Adastral Park, Ipswich : Offsite Highway Mitigation to A12 / Barrack Square / Eagle Way Roundabout and Gloster Road / Barrack Square Priority Junction

Technical Note : Designer's Response to Road Safety Audits at Stage 1

14th September 2017

Stage 1 Road Safety Audit

Off-site Highway Mitigation: Foxhall Roundabout Mitigation Swept Paths from A12 (South)

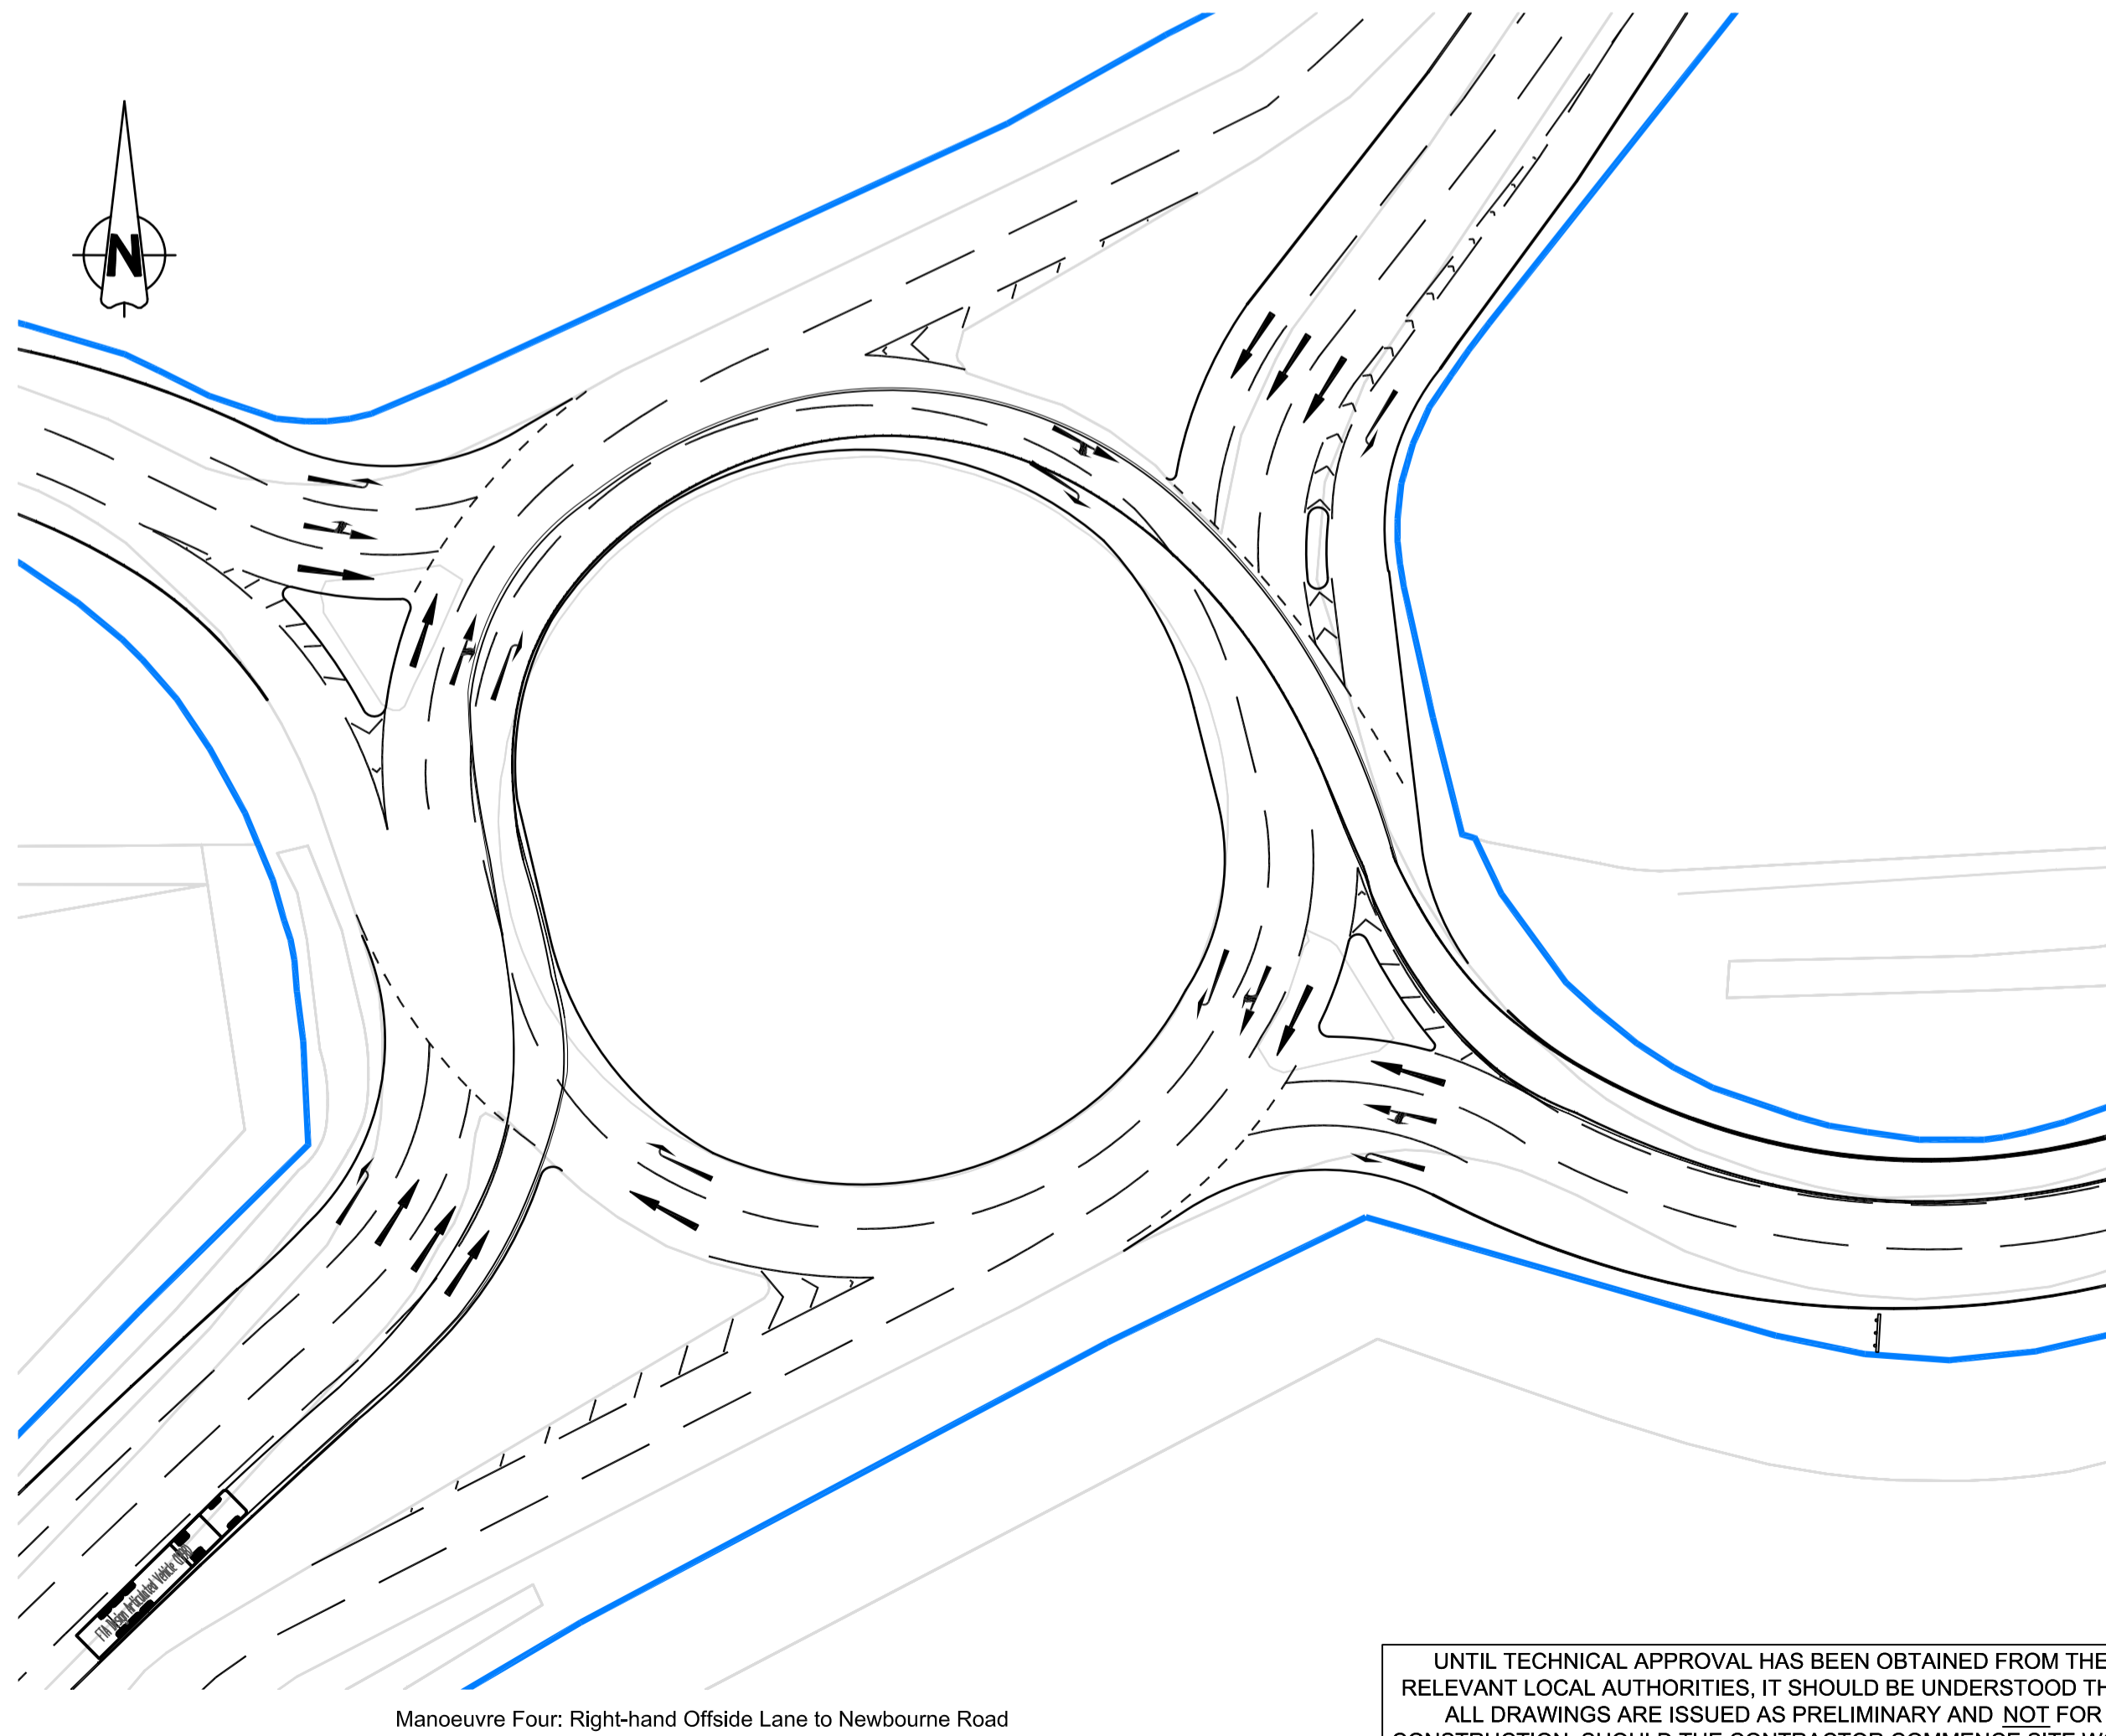
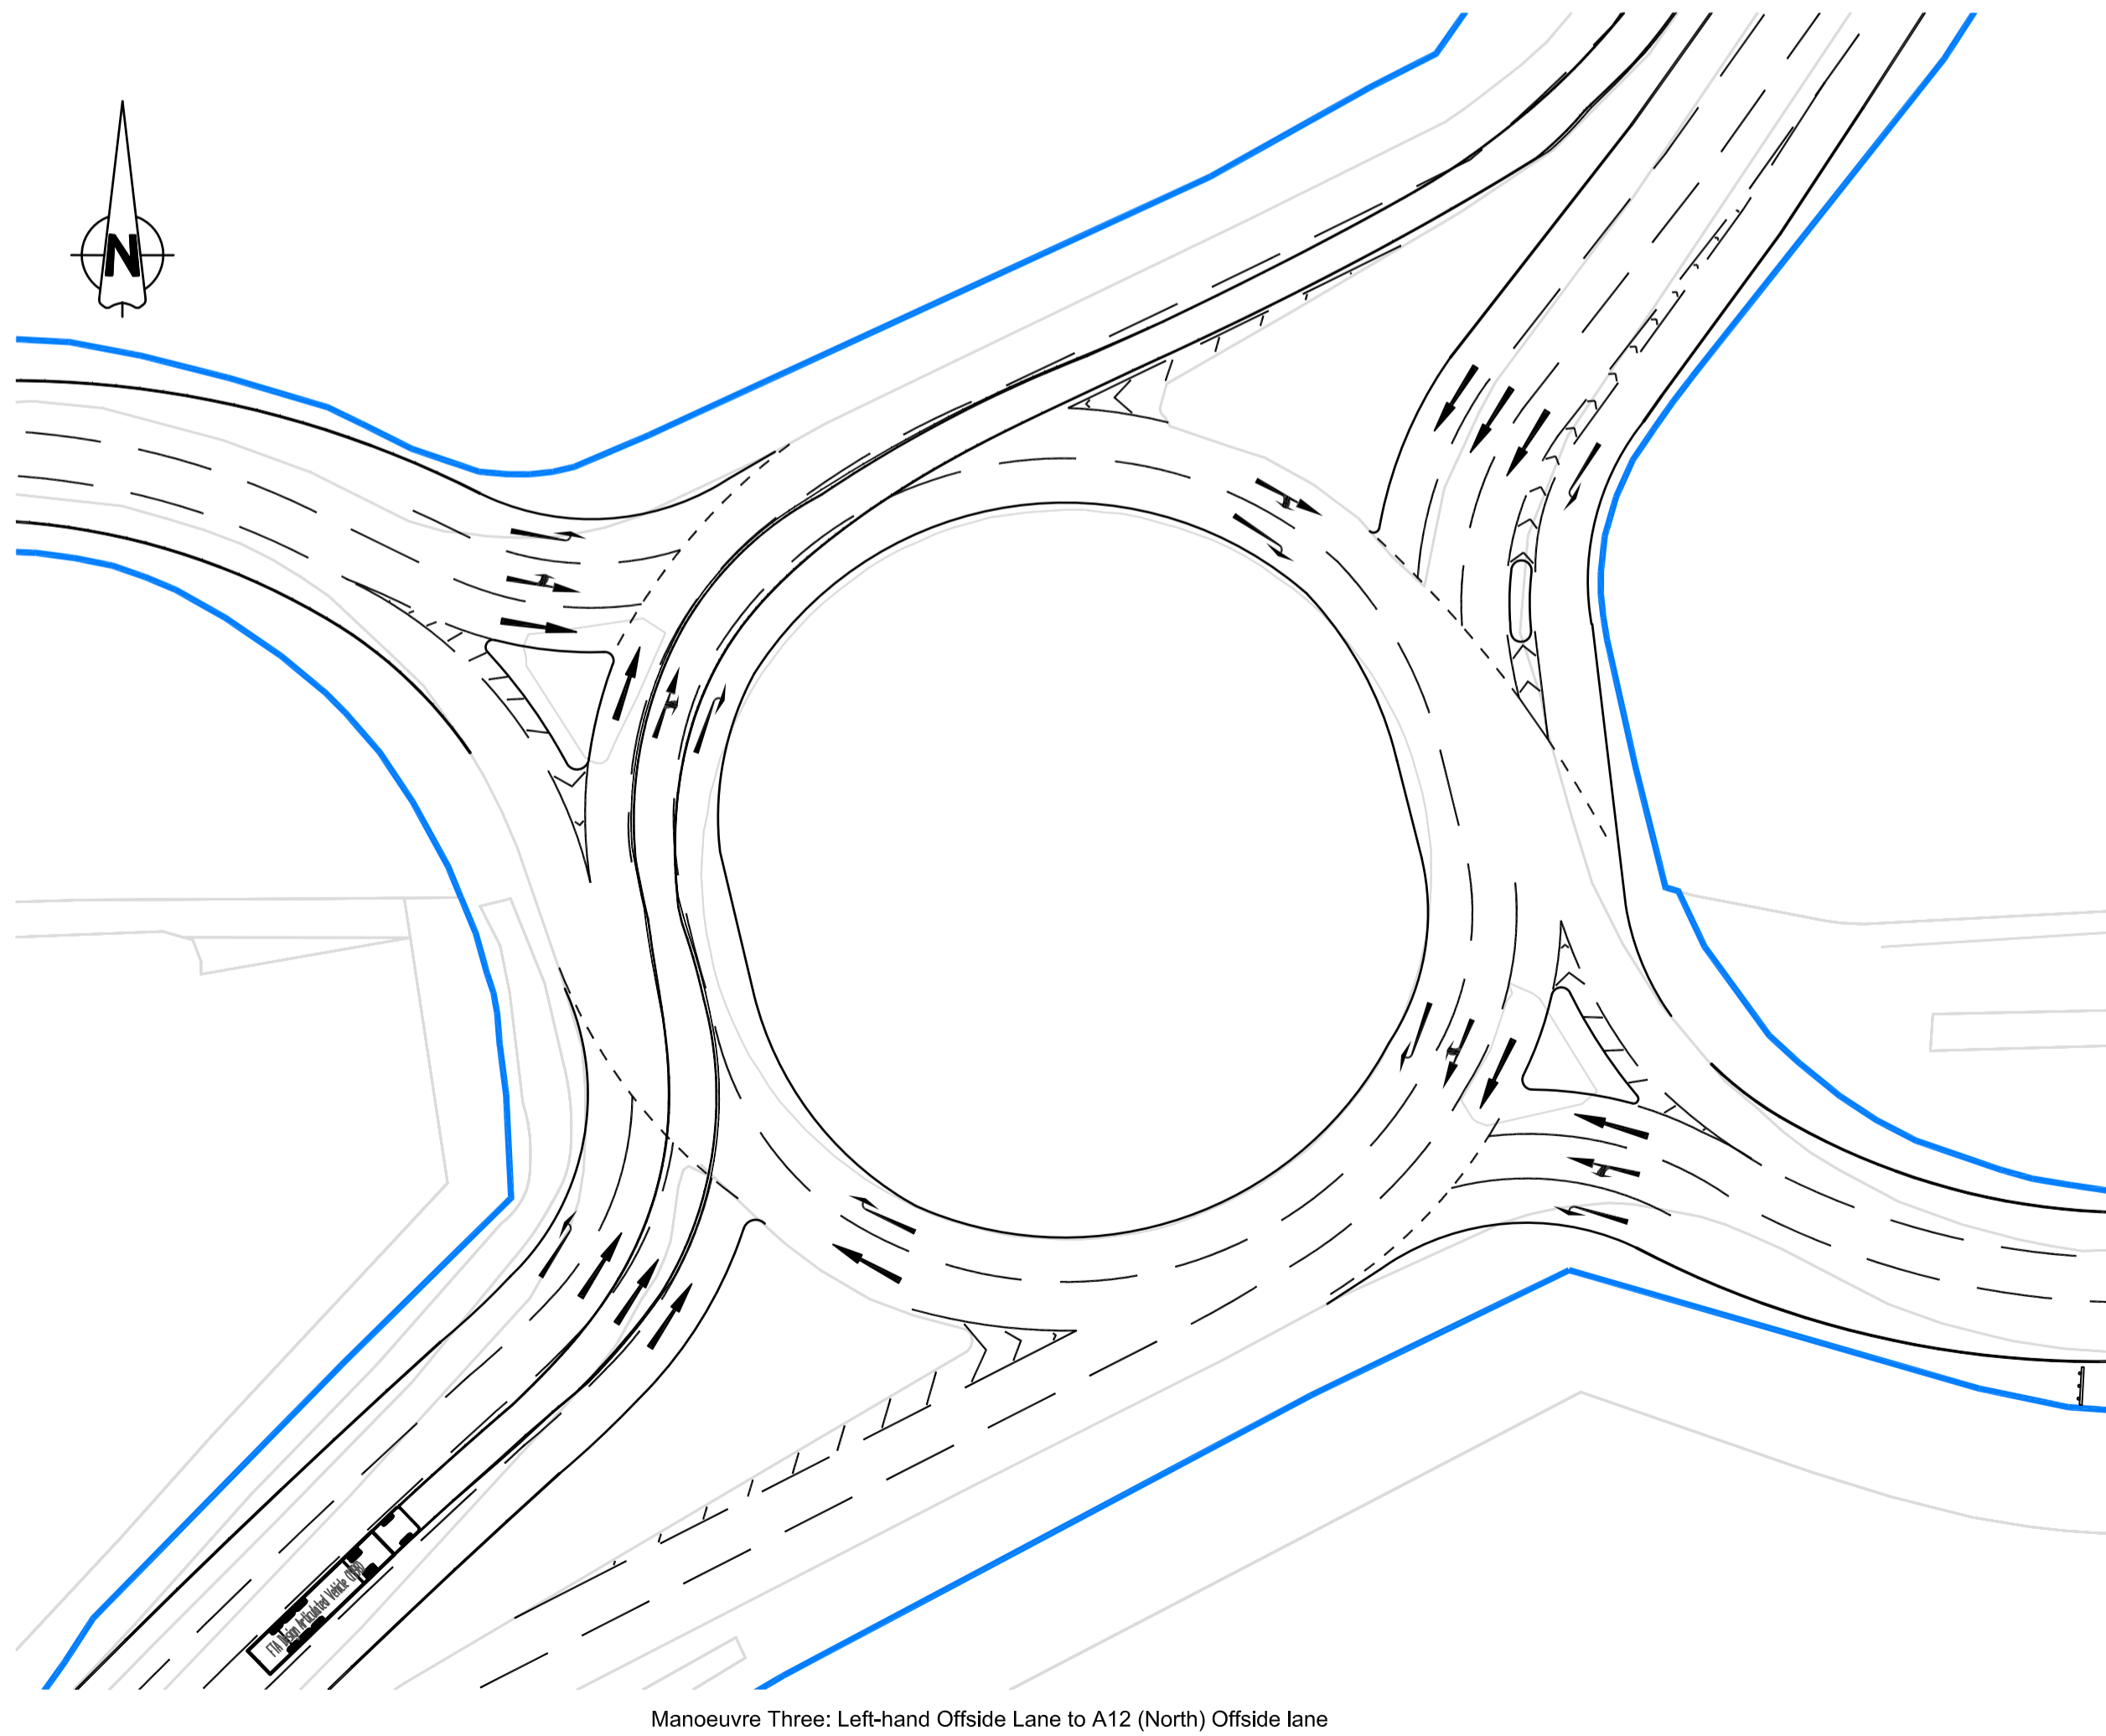
Summary: Risk of sideswipe accidents. The layout indicates a very narrow centre lane on the southeast quadrant and a risk of the nearside lane not being wide enough for the radius required to be traversed on the southwest quadrant from the A12 southern arm.

Recommendation: Carry out swept path analysis to ensure that all vehicles can travel within the intended lanes and make adjustments as required.

BCL Response: *Swept path analysis has been carried out for all the possible manoeuvres across the south-east and south-west quadrants of the roundabout. These are indicated on drawings 10391-HL-36 and 10391-HL-37 in Appendix B.*
